KEIZER PLANNING DEPARTMENT
AMENDED STAFF RECOMMENDATION
Subdivision
Case No. 2024-04

TO: Theodore R. Naemura, Keizer Hearings Officer
FROM: Shane Witham, Planning Director
SUBJECT: Subdivision Case No. 2024-04
DATE: April 18, 2024

The applicant is requesting to divide a 0.93-acre parcel into 6 parcels ranging in size from approximately 5,016 square feet to 8,759 square feet. The property is zoned Single Family Residential (RS) and Low Density Residential on the Comprehensive Plan Map. The newly proposed lots will be served by a private access easement from McLeod Lane NE, proposed to be 24 feet in width. The property is located at 6255 McLeod Lane NE (063W36BB03700).

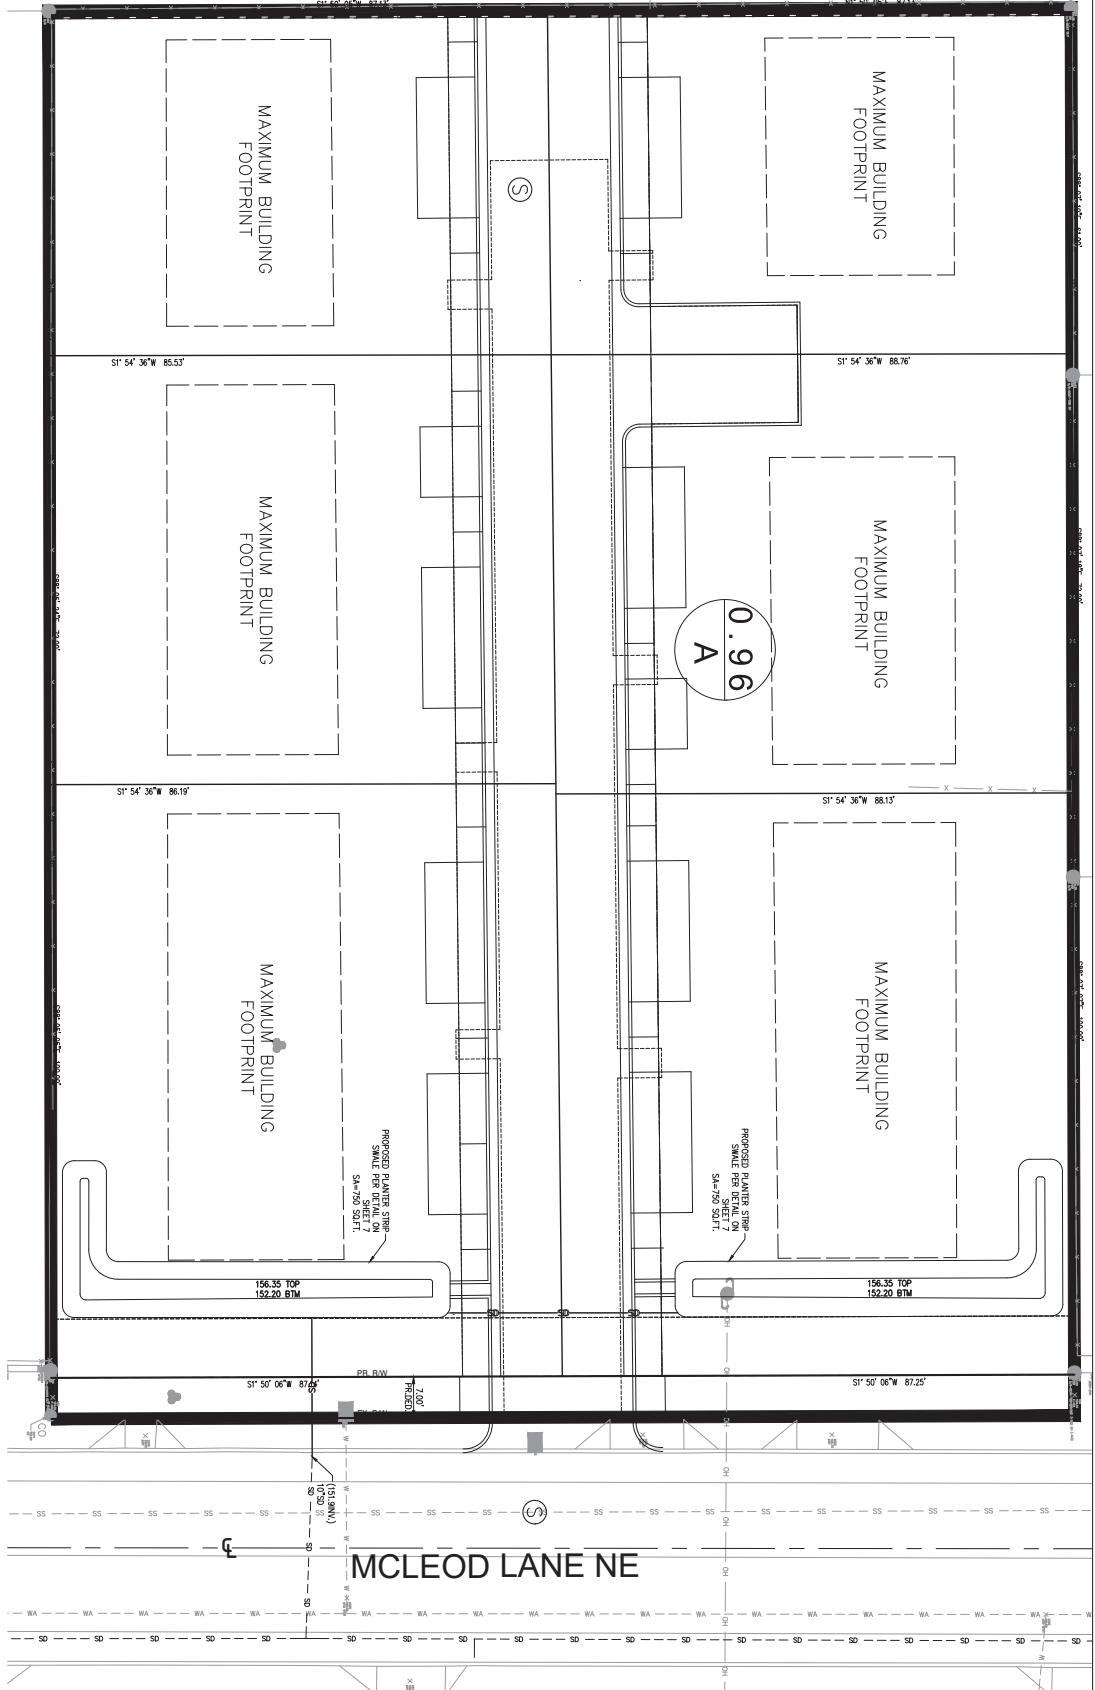
The applicant's submitted preliminary storm drainage plan is not acceptable to the City and will need to be revised prior to any development. The Public Works comments indicate they reviewed the submitted preliminary stormwater plans and report and that the information does not demonstrate reasonable conformance with the requirements of Chapter 400 of the Keizer Design Standards, specifically in the proposed site grading and size of the proposed facilities. The Applicant's engineer shall submit a final overall storm drainage and grading design with supporting calculations, demonstrating conformance to the Standards, for review and approval prior to the start of development.

- g) Public Works has reviewed the preliminary stormwater plans and report provided with this application. The information provided *does not* demonstrate reasonable conformance with the requirements of Chapter 400 of the Keizer Design Standards, specifically in the proposed site grading and the size of the proposed facilities. The Applicant’s engineer shall submit a final overall storm drainage and grading design with supporting calculations, demonstrating conformance to the Standards, for review and approval prior to the start of development.

- h) A grading and drainage plan shall be provided for the subject property in conformance with the Keizer Design Standards. The plan shall include details of adequate stormwater conveyance from all contributing areas across the subject property and shall include existing elevations and proposed lot corner elevations. The plan shall be submitted to and approved by the Public Works Department prior to the issuance of any erosion control or construction permits for the development.

SHEET TITLE: TREE PRESERVATION PLAN

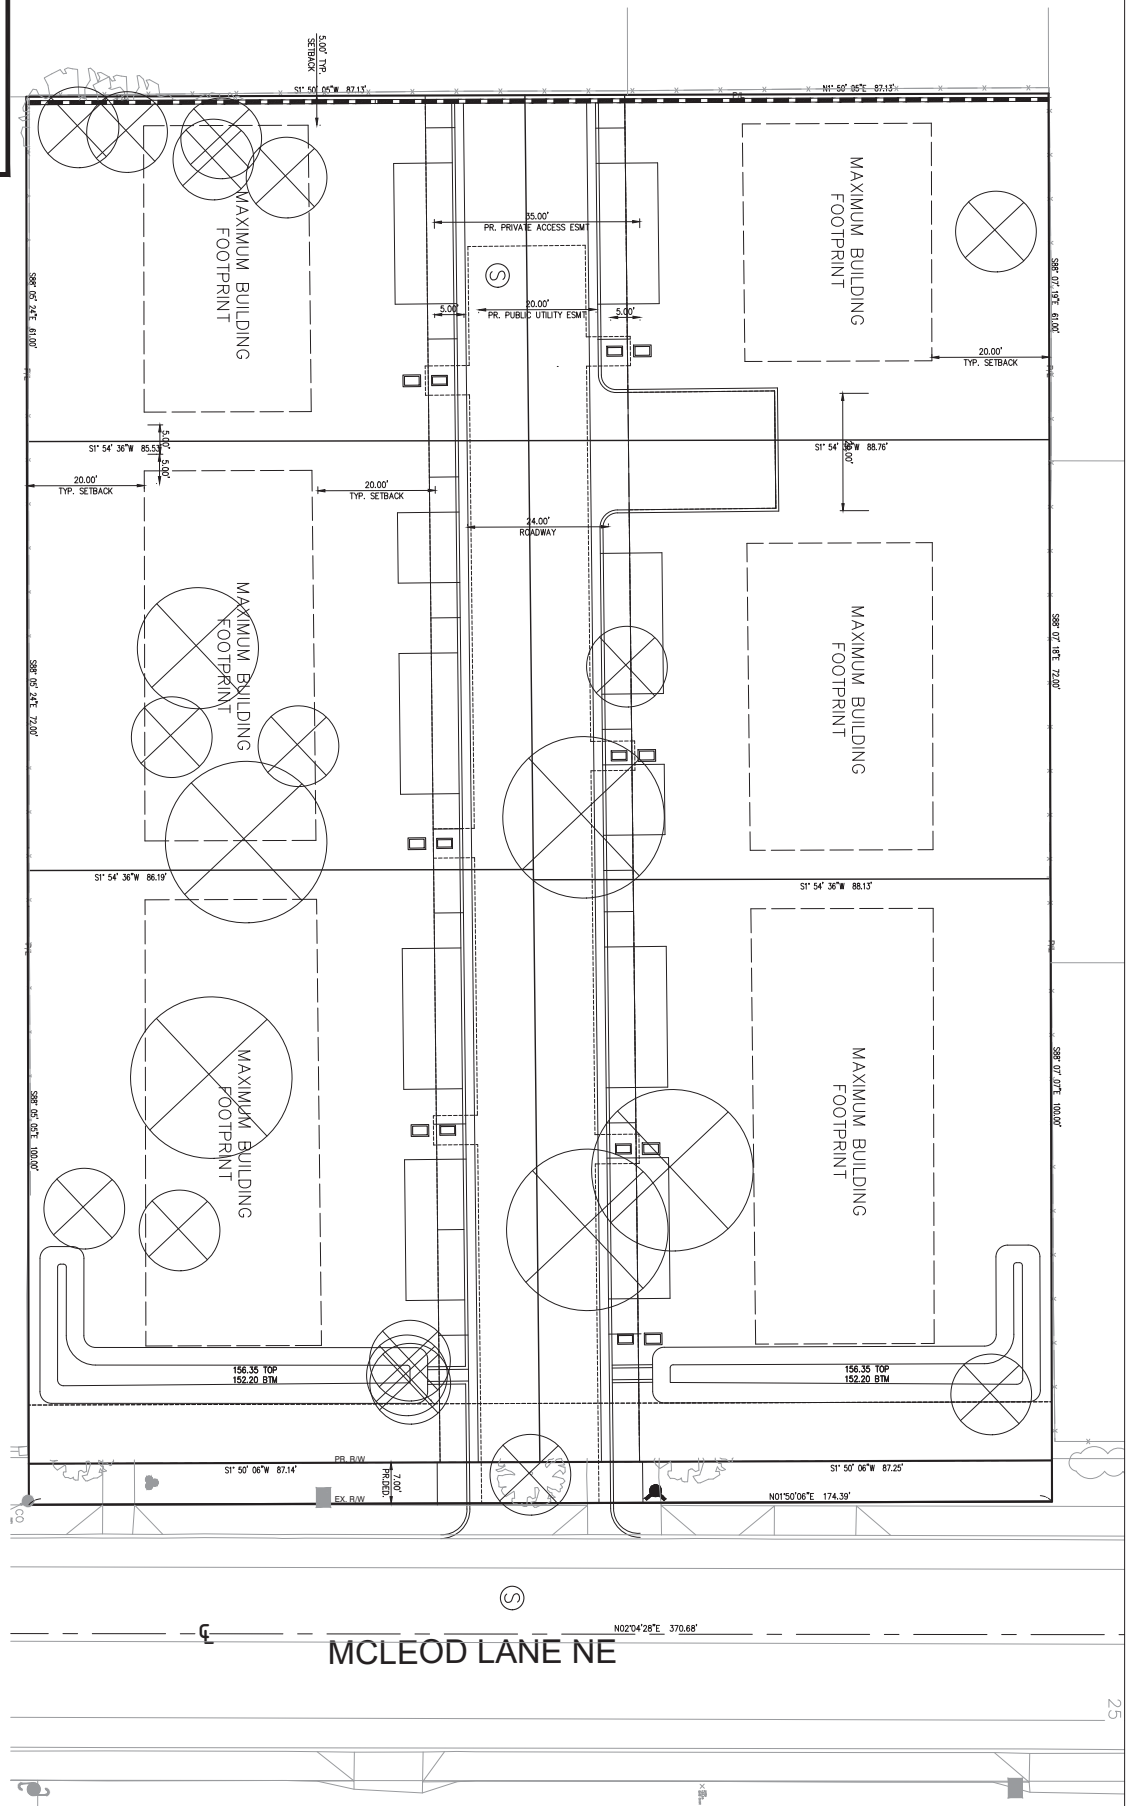
FINDING: The intent of this provision is to require planting of new trees to replace trees that are cut down as part of the development of a subdivision. In particular, this provision aims to replace trees that are identified as being “significant trees” which are trees that are equal to or greater than 50’ in height or 12” in diameter. The applicant submitted a tree plan that shows 22 trees are proposed to be removed from the site to allow for the subdivision development. The applicant’s site plan was unclear as to whether or not all of the existing trees qualify as “significant” according to the standards of the KDC, and were not labeled with sizes. The KDC requires the replacement of trees removed at a 2:1 ratio. Therefore, if all 22 trees shown to be removed qualify as significant trees, a total of 44 trees would be required to be planted to mitigate the trees removed.

Staff recommends the applicant submit a revised tree removal and replacement plan for review and approval by the Planning Department prior to final plat approval. The tree removal plan shall clearly identify all “significant” trees that will be removed. The tree replacement plan shall identify how many trees will be planted on each lot and shall include the location and quantities of required streetscape trees previously addressed in this report as well. While it is unlikely

5. The applicant shall submit a revised Tree Removal and Replacement Plan to the Planning department for review and approval, showing the approximate location of all streetscape and replacement trees to be planted. Significant trees removed shall be replaced at a ratio of 2 replacement trees for every 1 tree removed.

If all 22 trees qualify as significant trees and are removed, a total of 44 trees shall be provided within the subdivision or accounted for in an off-site mitigation plan. Off-site mitigation should be utilized to avoid overcrowding. Payment into the City's landscape mitigation fund must be made prior to plat approval. If the applicant wishes to propose larger specimen trees for replacement, the Planning Director may reduce the total number of replacement trees required. Regardless of how many trees are provided through off-site mitigation, streetscape trees will be required (16 total within subdivision) to be planted for each lot according to the requirements identified in this report. In addition to streetscape trees, a minimum of 1 replacement tree must be provided on each lot.
